RE: Ewing Gravel Pit, DRMS File M2023-033
Adequacy Response 1

The attached letter addresses each adequacy item in your December 11, 2023 letter regarding the Ewing Gravel Pit. Items marked as adequate are omitted. Revised exhibits and maps are attached as well. Feel free to contact my office with any questions.

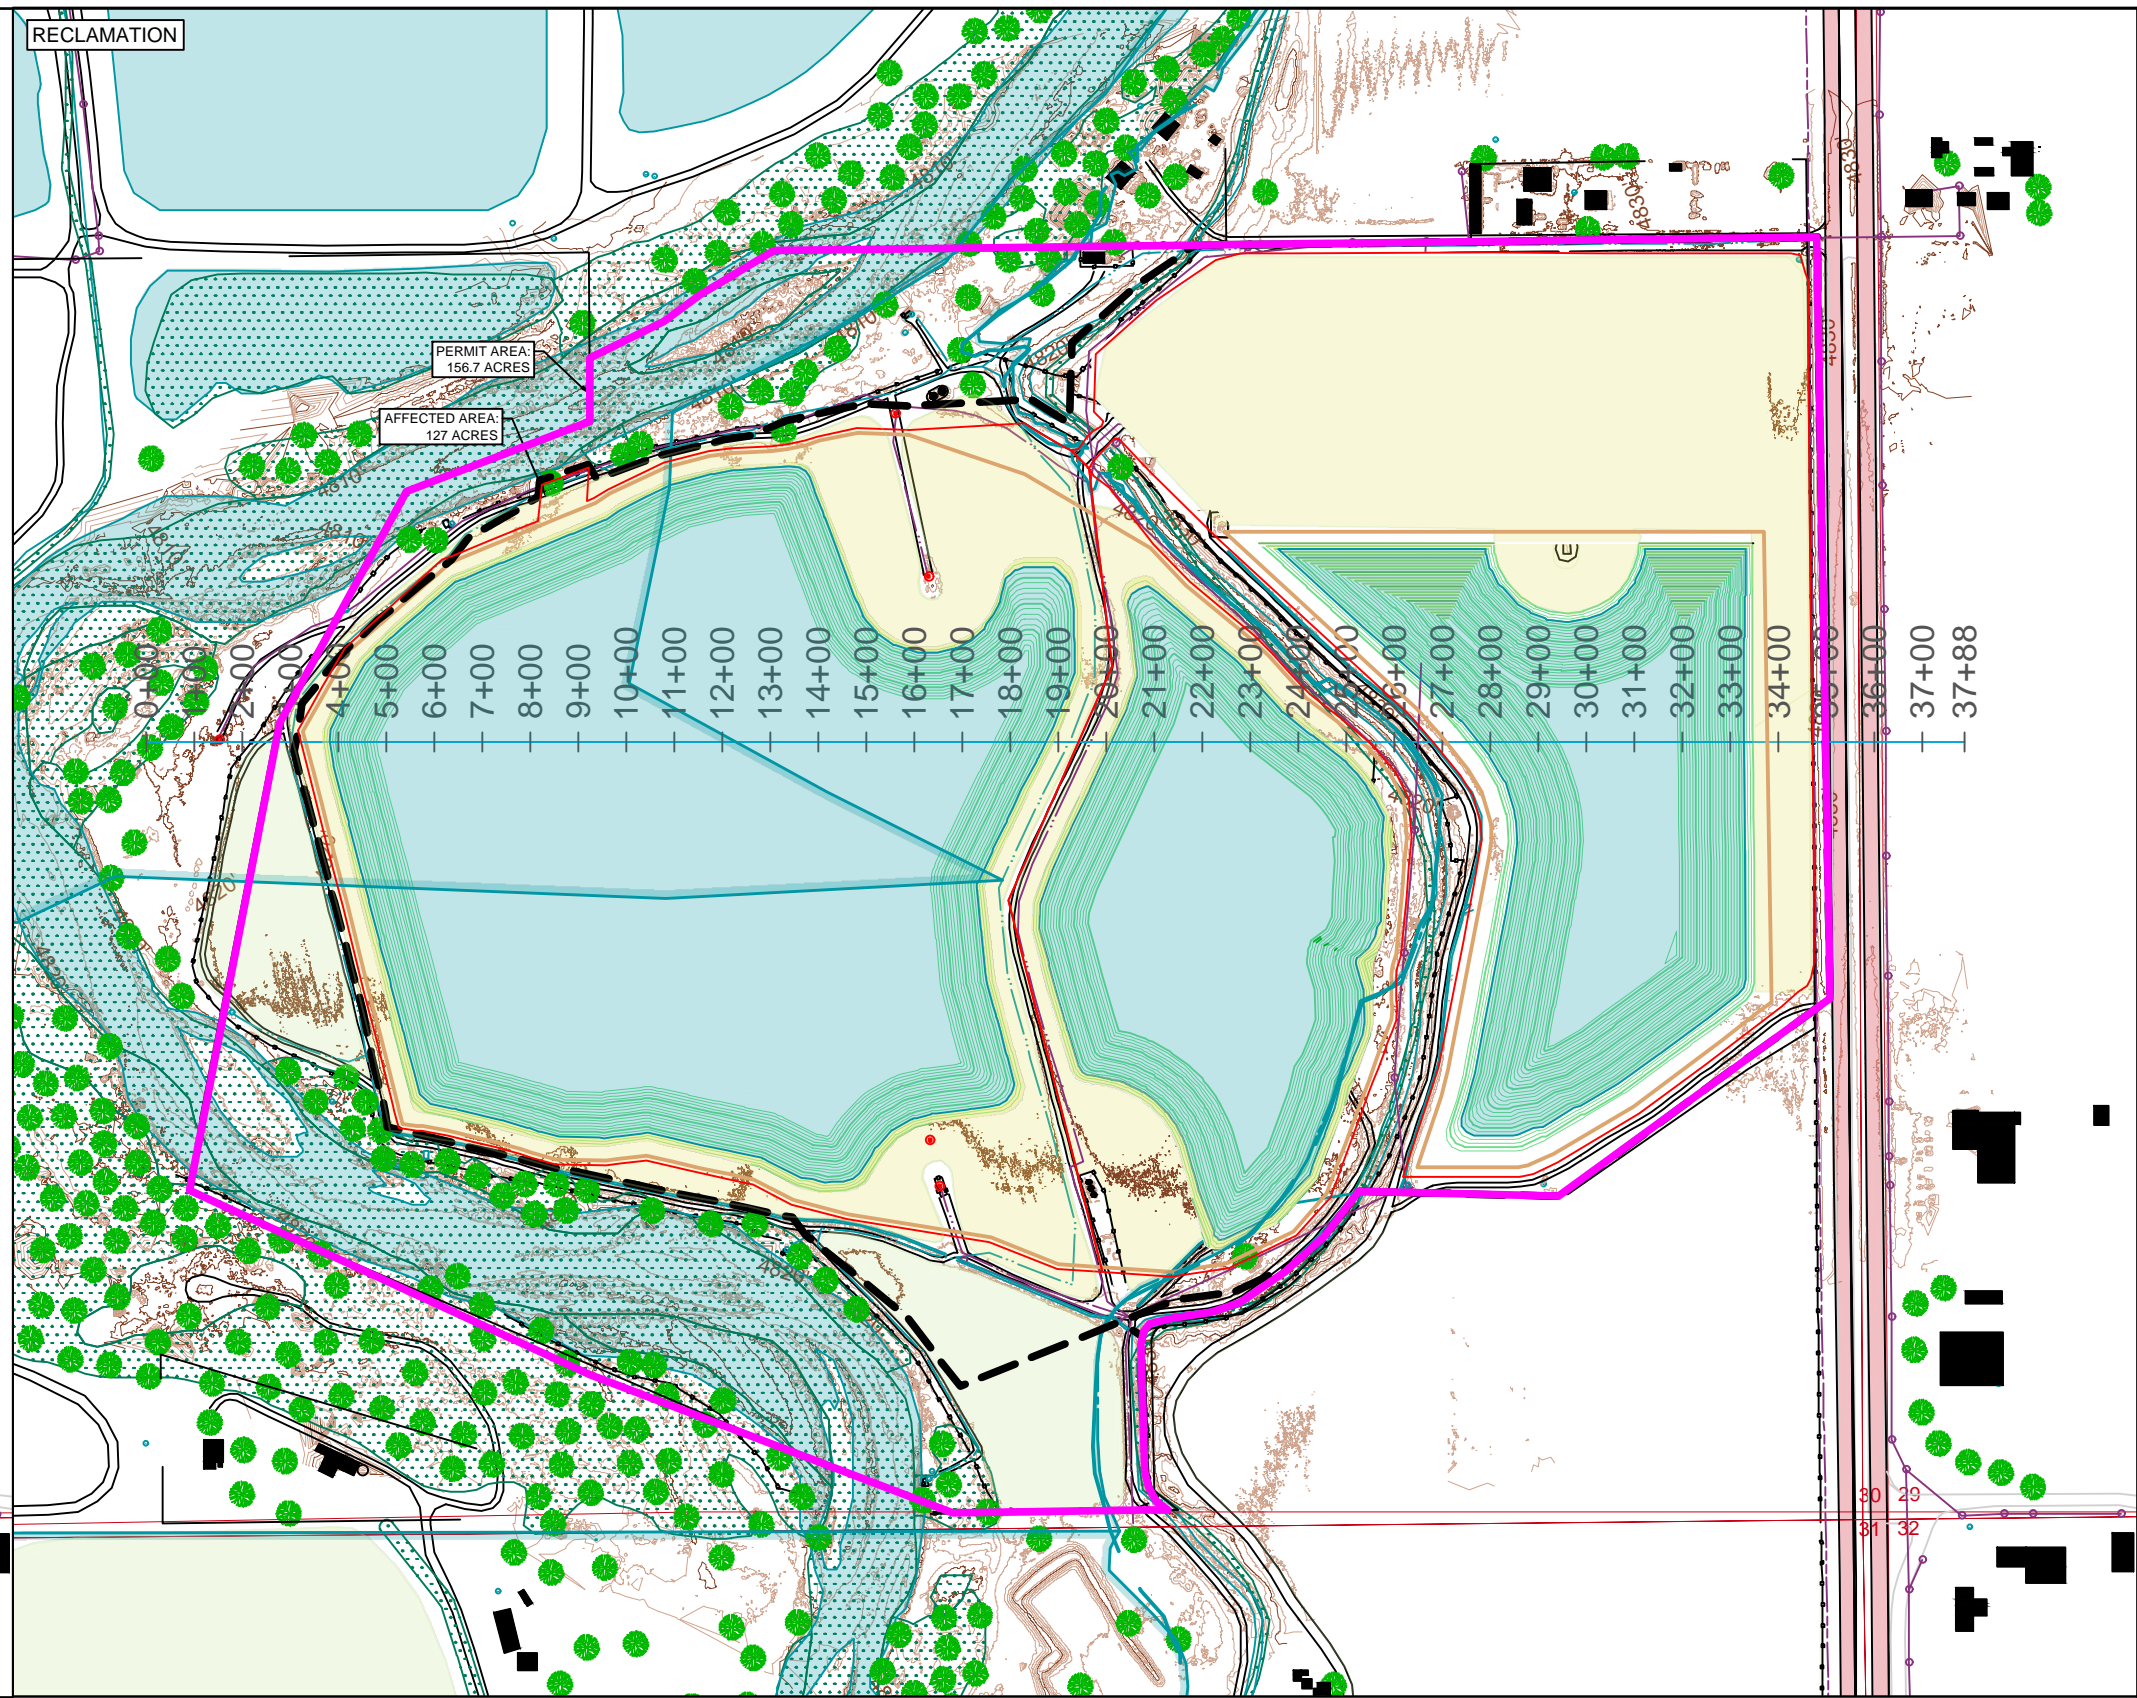
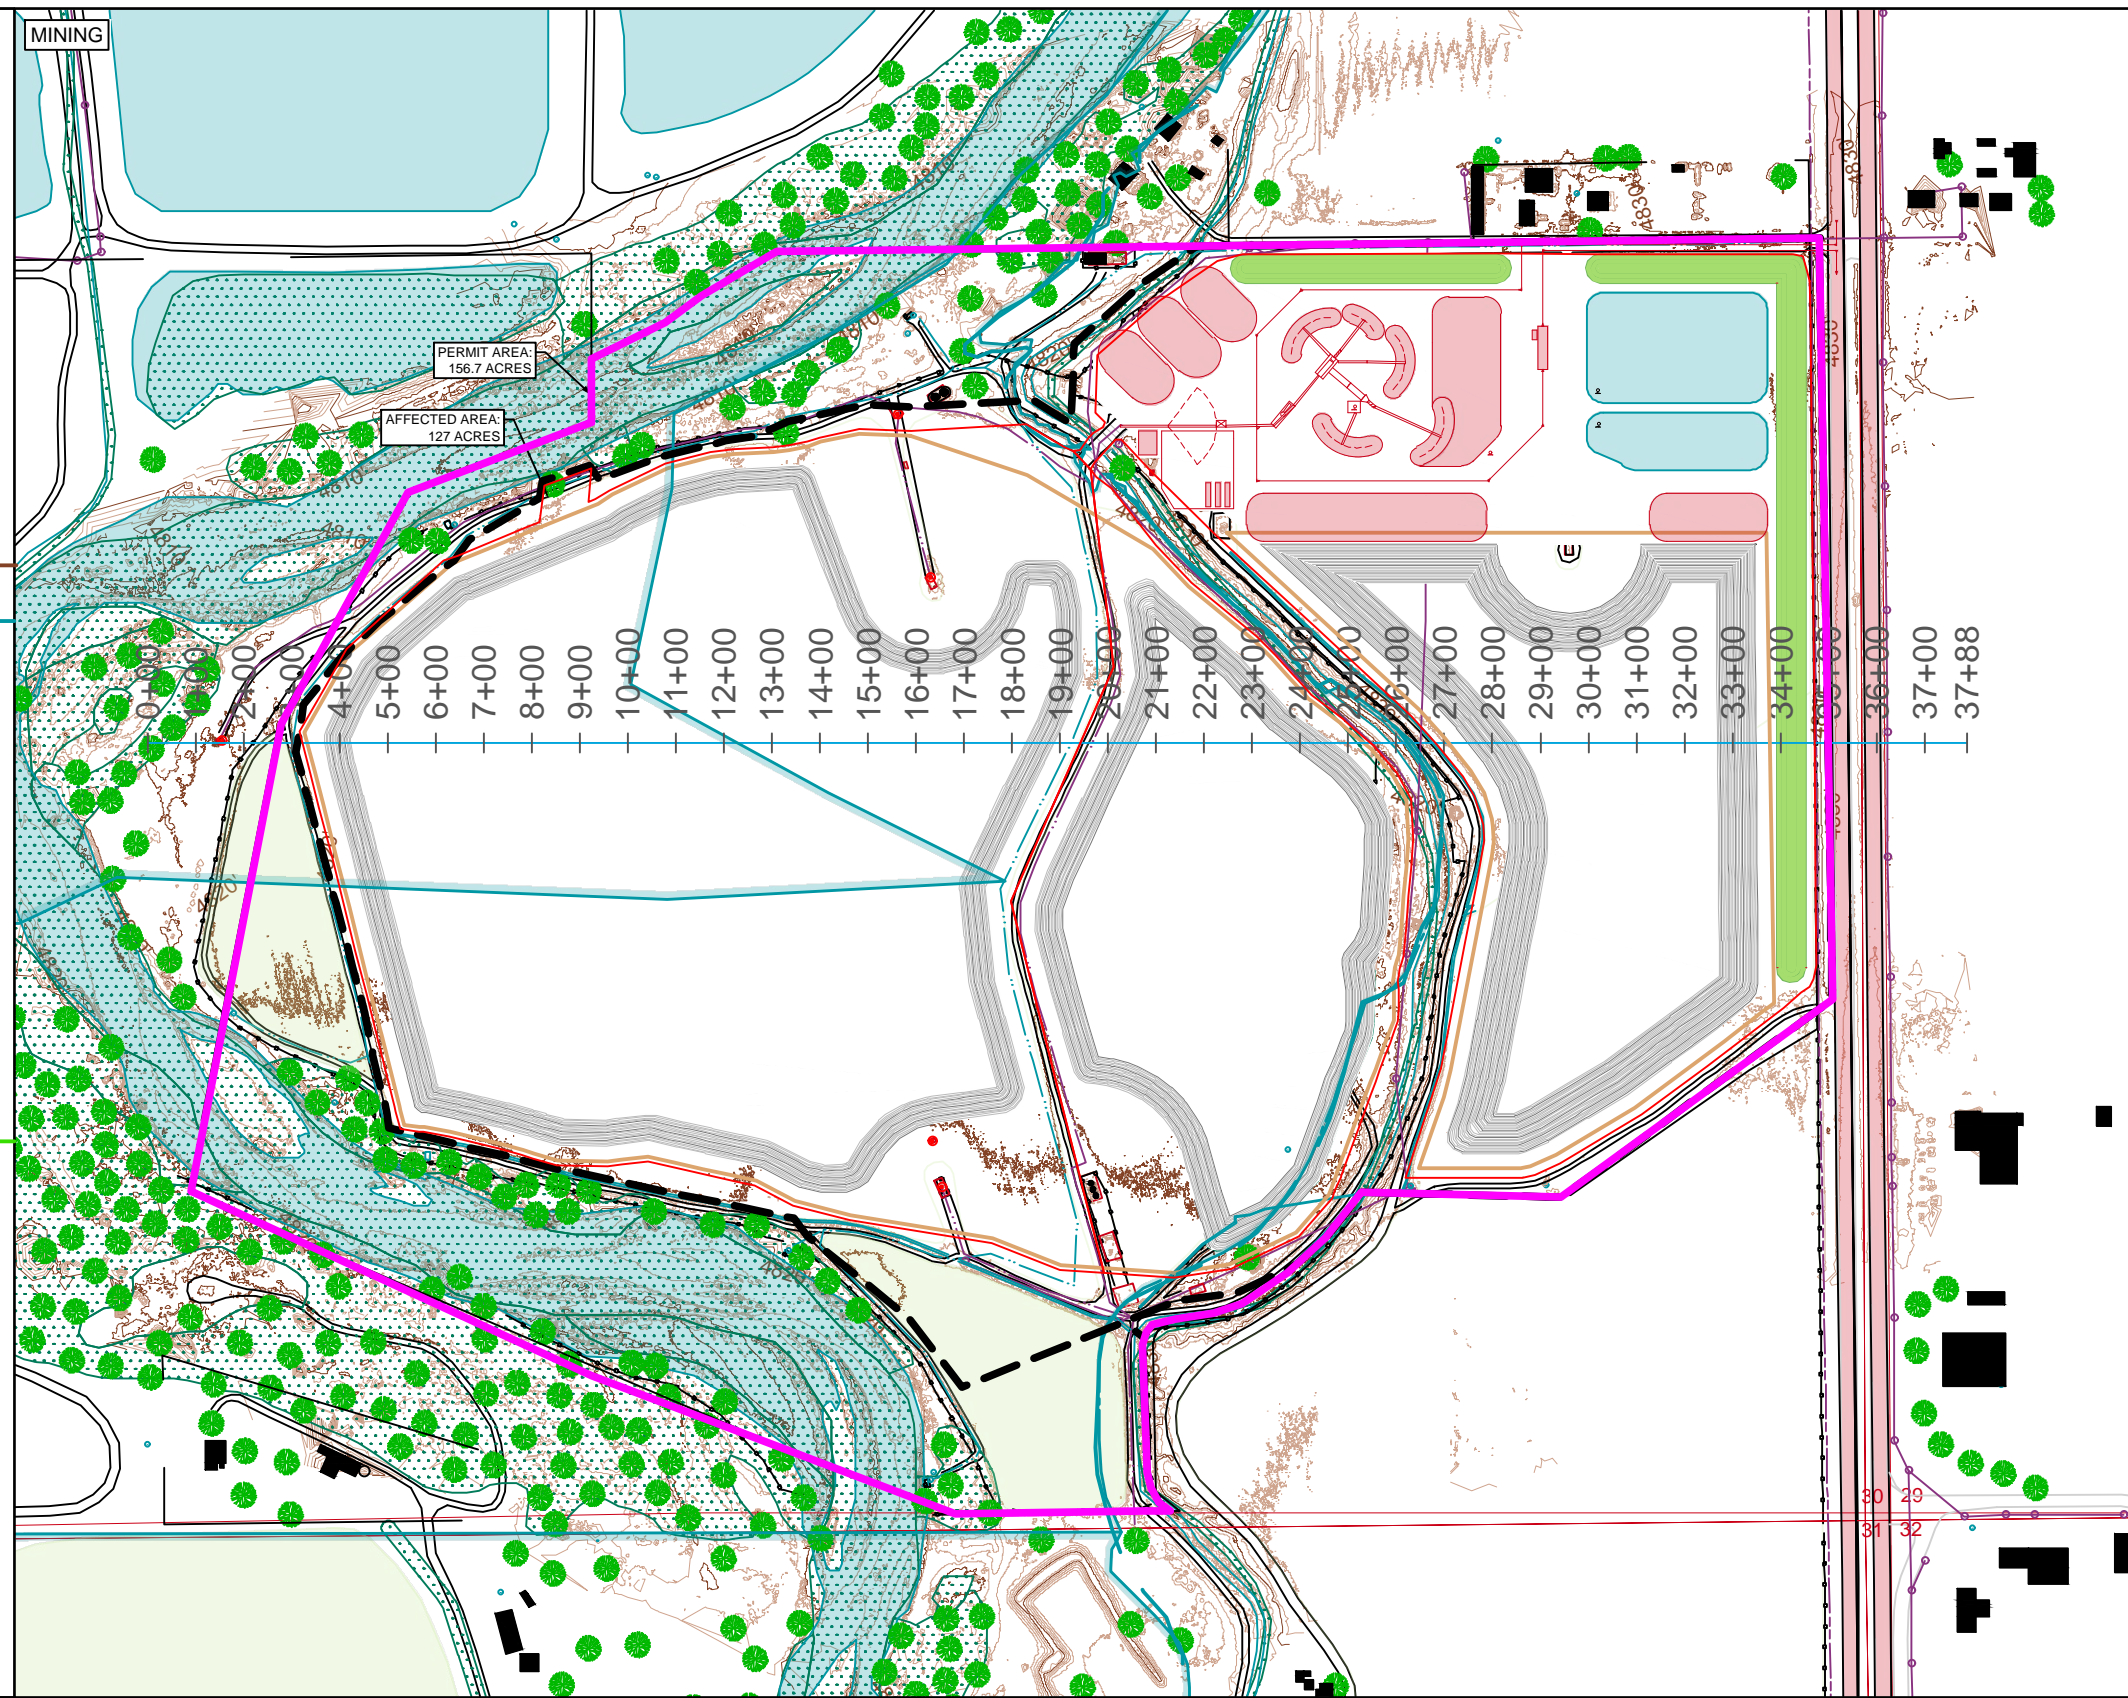
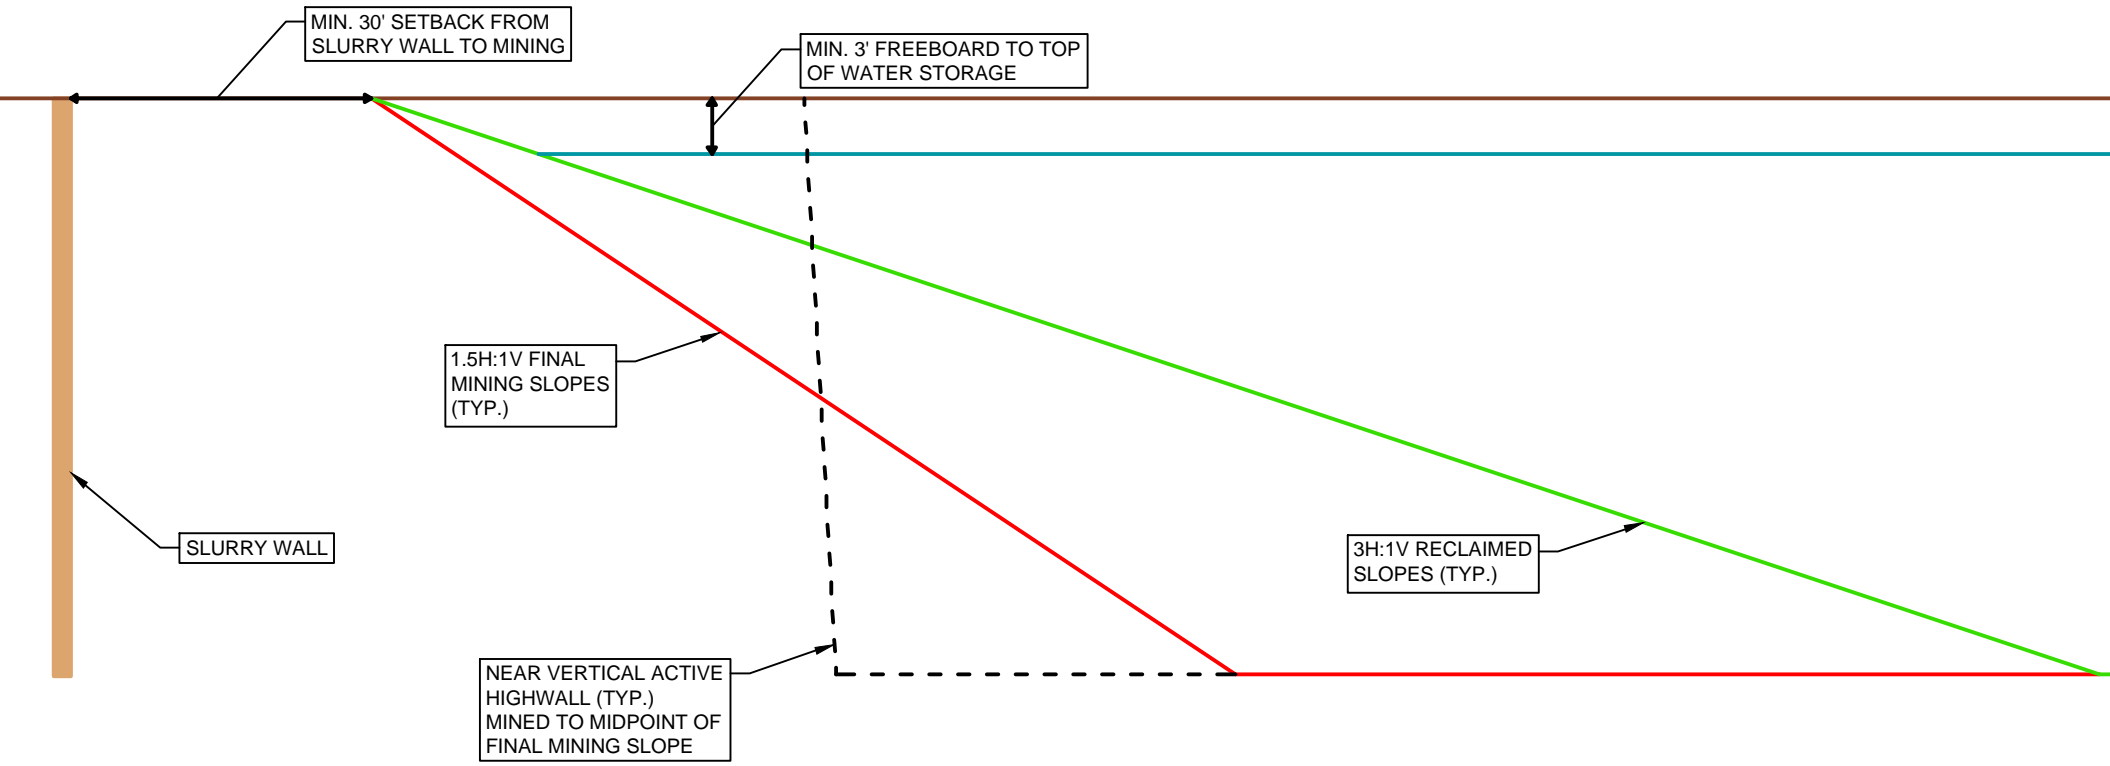
- 2) *The application states that significant amounts of overburden, sand, and topsoil will be maintained on-site for reclamation, and that all stockpiles will be placed in Pod 3 outside of the Flood Plain. Please show the locations and expected volumes of all topsoil and overburden/sand stockpiles on the Mining Plan map. Note that the Act/Rule requires that Topsoil and Overburden be segregated and maintained separately for reclamation.*

- 4) *Please include the affected acreages of the 3 “Pods” on the mining plan map.*

- 5) *The permitted discharge point referred to in the application in section G-1 is not shown on the Mining Plan map – please correct.*

- 8) *Please correct the text in the first paragraph of page D-2 which states “Excavated material will be conveyed to the center of the site for processing”. The application as provided does not show or discuss any conveyor routes. Please clarify how mined material will be transported to the Processing Area at the north end of Pod 3 as shown on the Mine Plan map. If conveyors will be used, they will need to be shown on the Mine Plan Map.*

Map C-2 has been revised with labels for the topsoil and overburden stockpile locations.

Map C-2 has been revised with labels of the area of the three mining pods.

The permitted discharge point has been added to Map C-2.

The text on page D-2 has been corrected and Map C-2 updated to show a typical conveyor route from the mining pods to the process area.
